SUBJECT: Coastside Design Review Continuance 0 El Granada Boulevard, El Granada APN 047-151-120; County File No. PLN 2019-00162

At its meeting of February 13, 2020, the San Mateo County Coastside Design Review Committee (CDRC) considered your application for a Design Review Permit to allow construction of a new two-story 2,772 sq. ft. single-family residence, plus a 481 sq. ft. attached two-car garage, on a 5,230 sq. ft. legal parcel (legality confirmed PLN 2016-00031). No significant tree removal and a grading permit for 330 cubic yards is proposed. The project qualifies for a Coastal Development Exemption and is not appealable to the California Coastal Commission.

PLN 2019-00162 ADDITIONAL REVISIONS

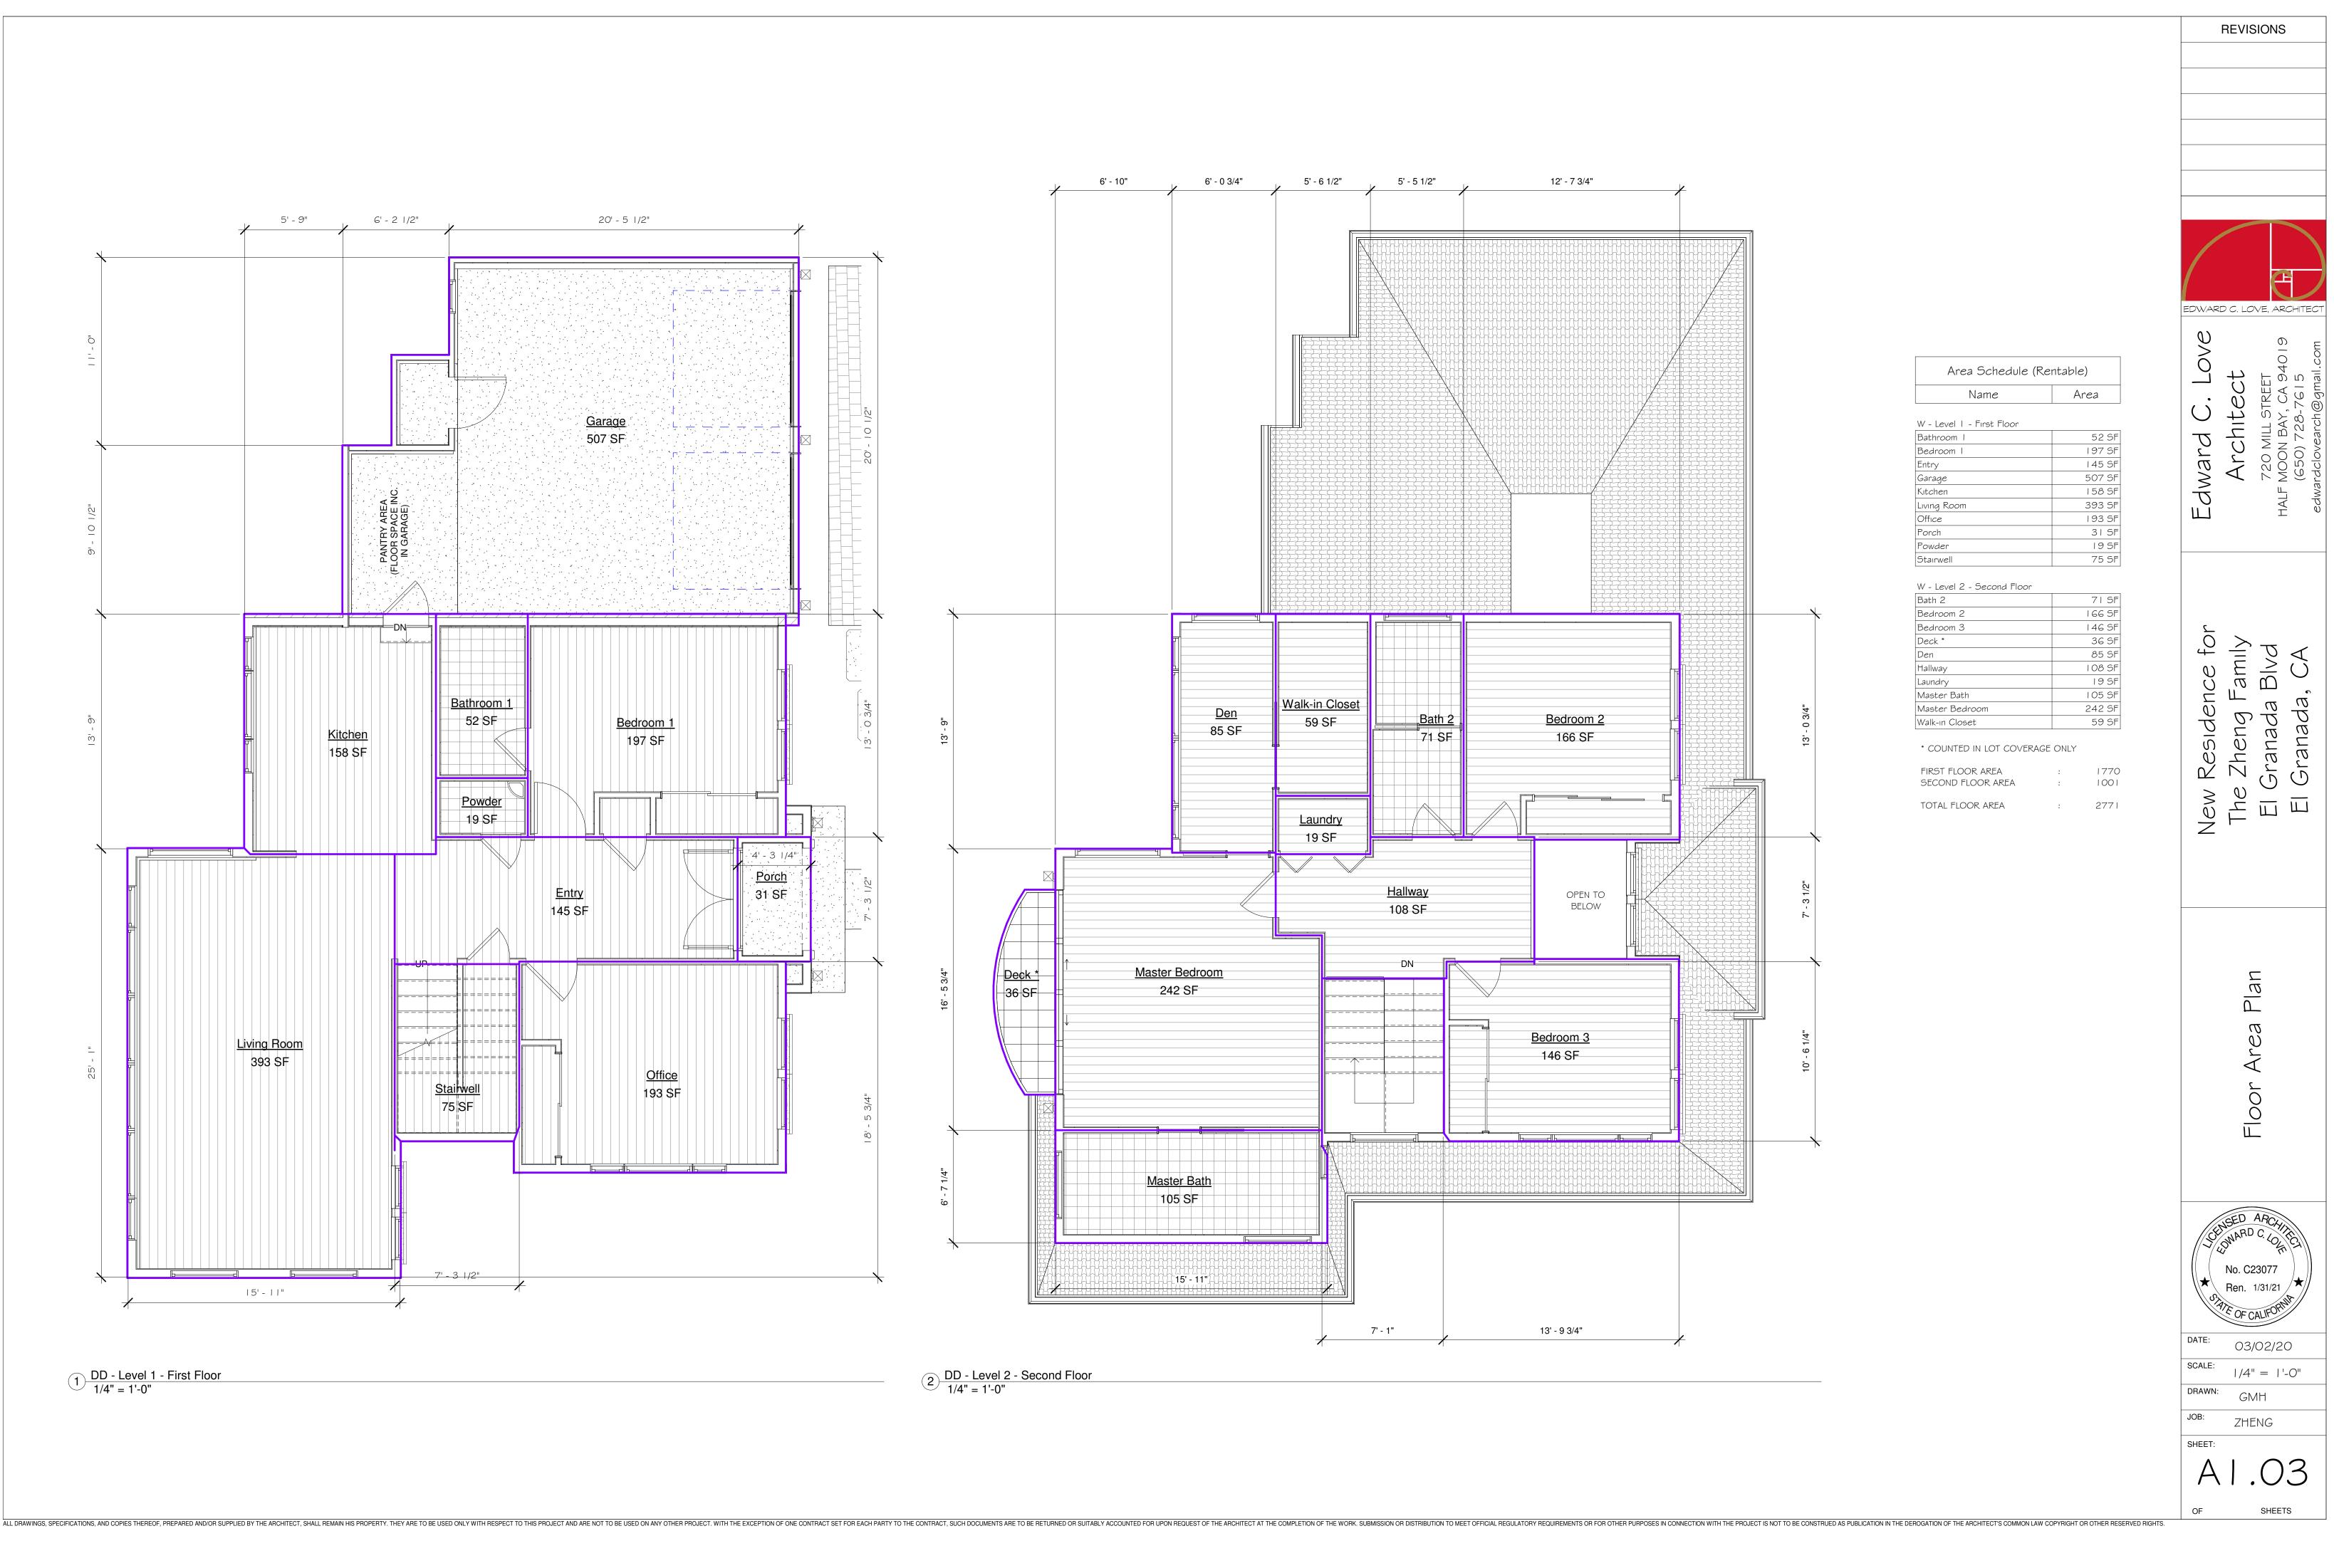
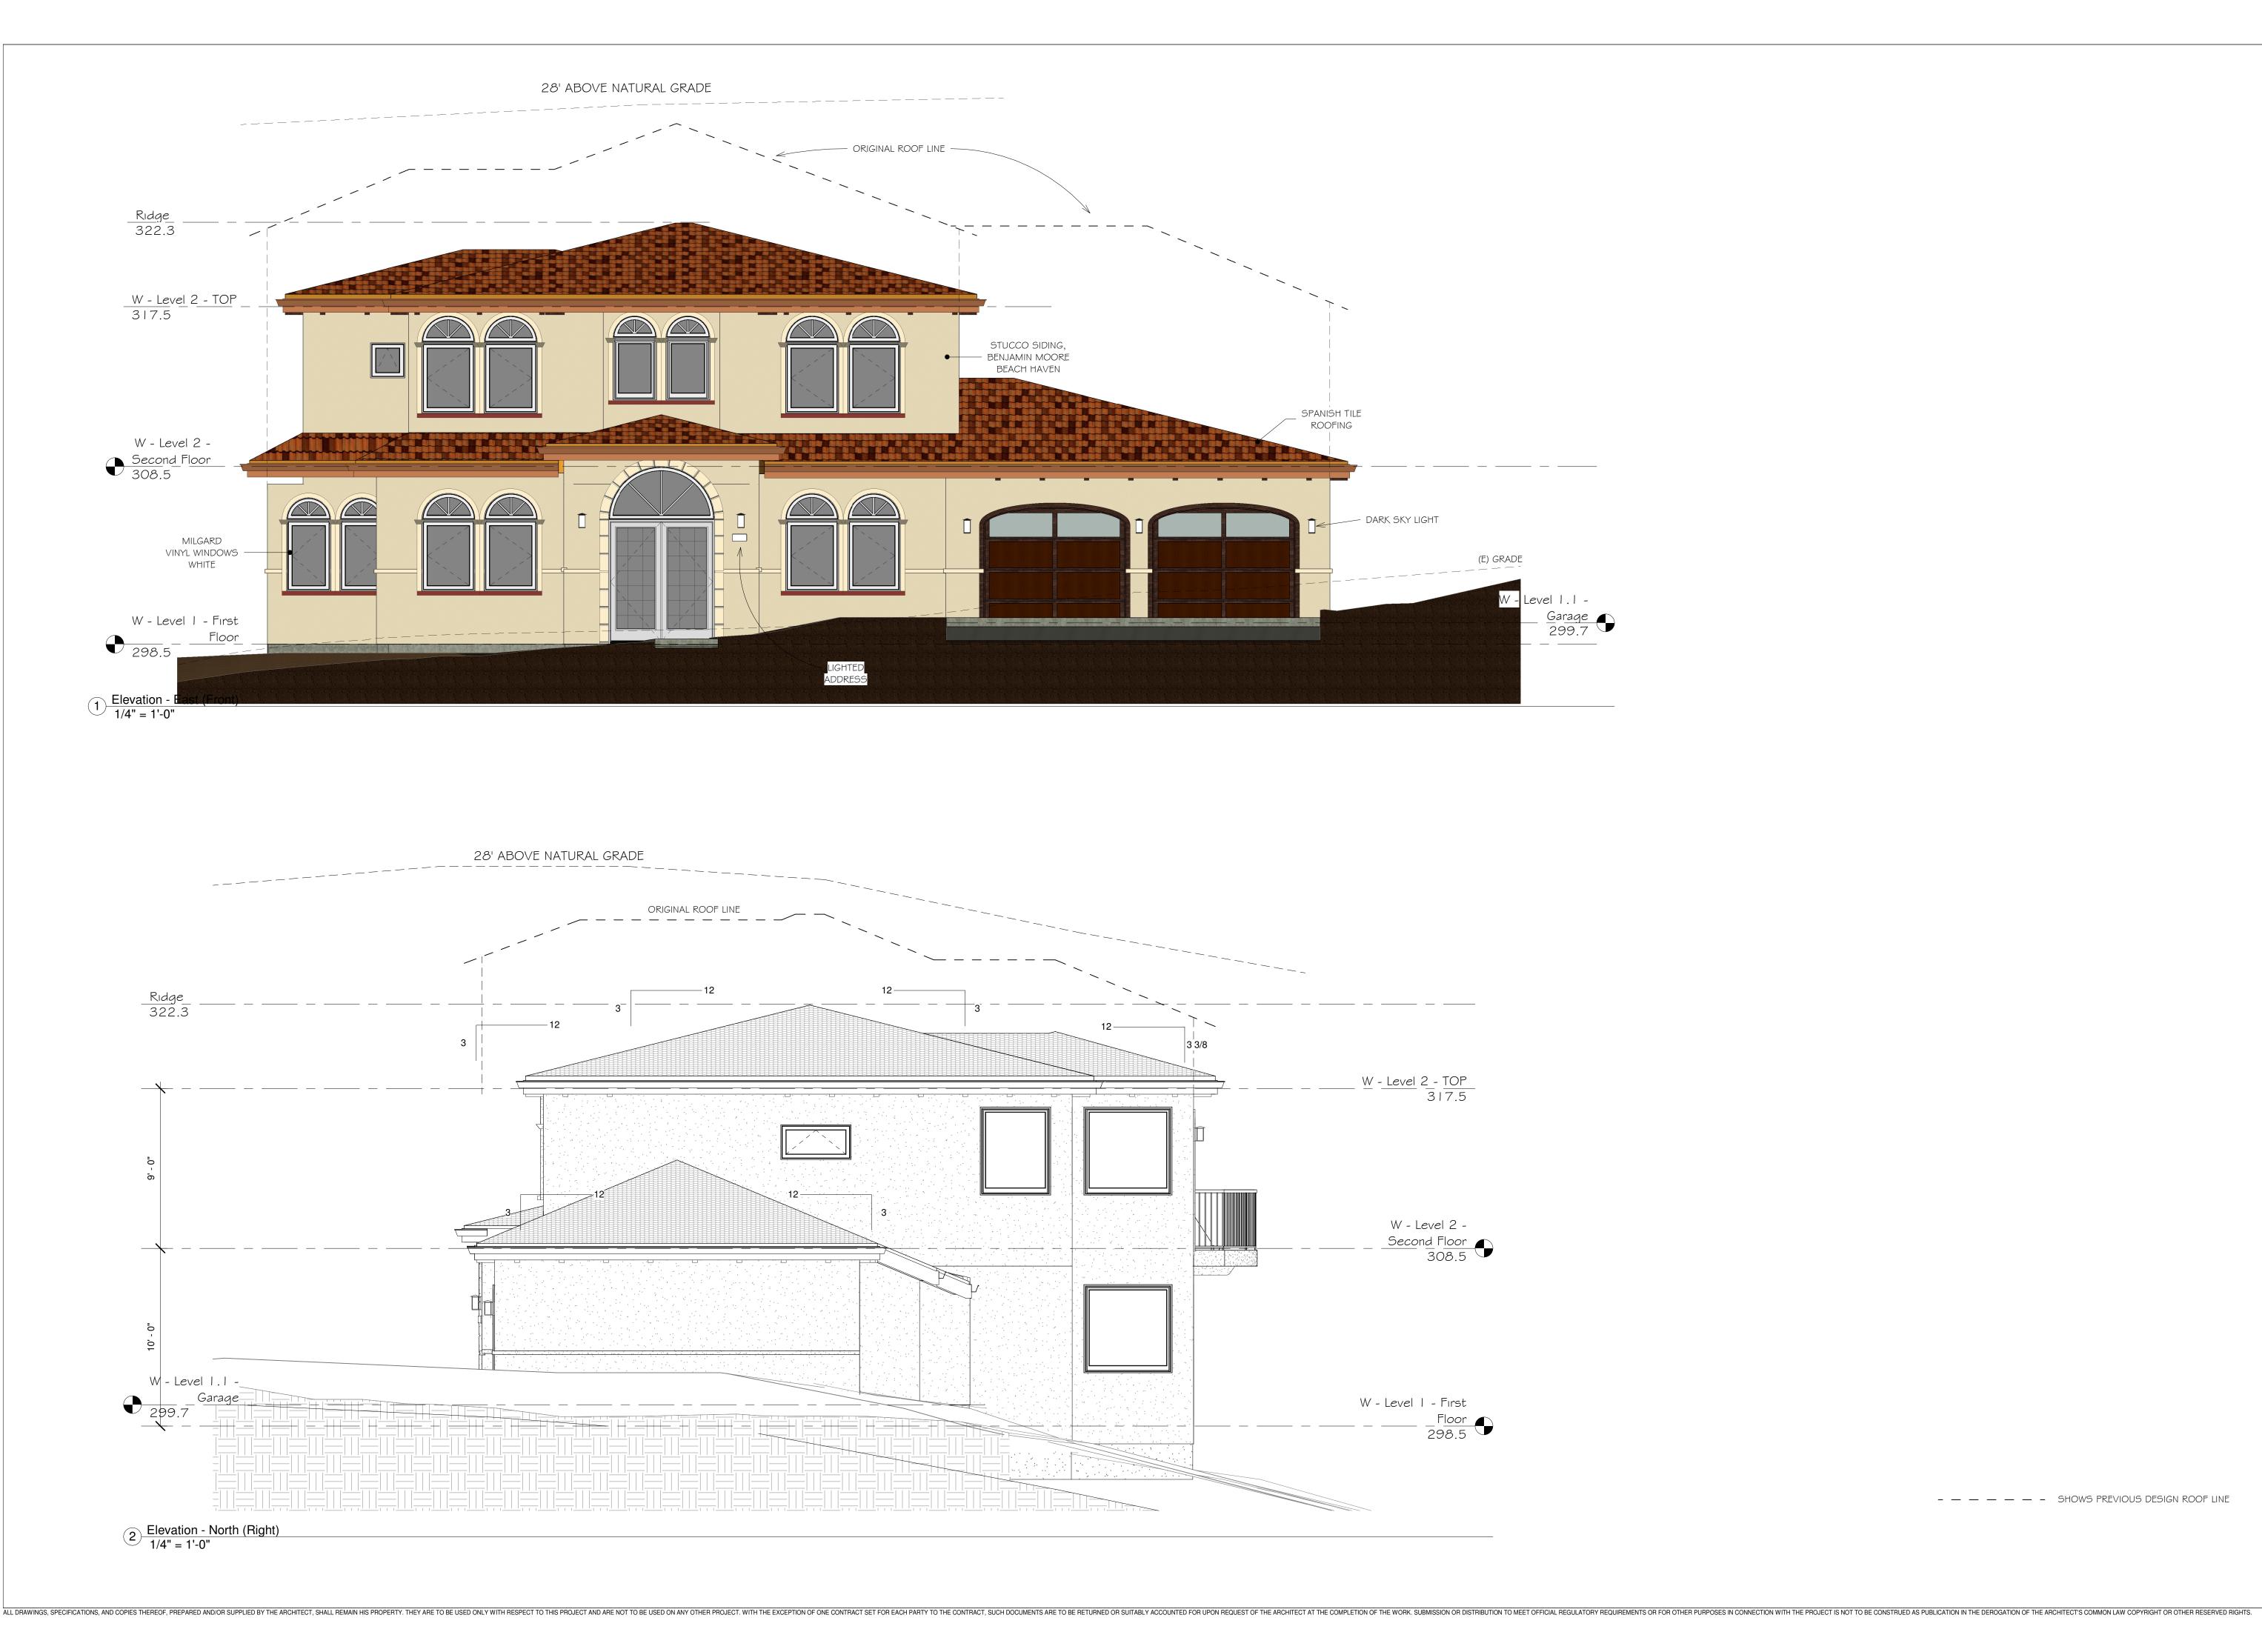
- 1. <u>Recommendations Discussed Include</u>:
 - a. Make the shed roofs that flank each side of the front entry larger to set the second floor back.
 - b. Change the entry expression to be a single-story expression.
 - c. Shift the master bedroom suite away from the south property line in order to introduce the first-floor roof and set the second-floor back from the first-floor.
 - d. Remove the story poles within one week.

- 2. <u>Suggestion</u>:
 - a. Step down the master suite/living room/kitchen area to visually break up the roofline and follow the natural grade.

- SECOND FLOOR FRONT & SOUTH WALL NEAR FRONT OF PROPERTY HAVE BEEN SHIFTED BACK
- ENTRY EXPRESSION IS SINGLE STORY
- MASTER BEDROOM SOUT WALL SHIFTED 2 FEET TO NORTH

– – – – – SHOWS PREVIOUS DESIGN ROOF LINE
